# UNITED STATES PATENT AND TRADEMARK OFFICE

### Office Action Summary

10/538,296

## **DETAILED ACTION**

FIG. 2

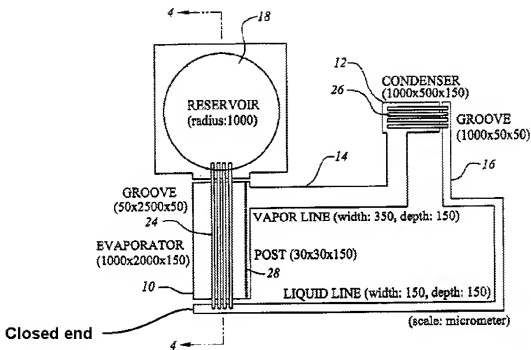
a second base plate 21 including a face with a first concavity 10, a second concavity 12, a first ditch 14 forming a channel between the first and second concavities 10, 12, and a second

ditch 16 forming a channel with a closed end (Figures 2 and 4A, marked up, below) between the second concavity 12 and the liquid suction and retention unit;

but does not disclose resin bonding the base plates, the first base plate covered with a protective film, nor a third concavity on the second base plate.

FIG. 4A

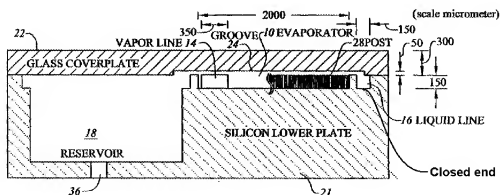
Regarding claim 18, Figure 4A discloses the first base plate 22 is disposed above the second base plate 21.
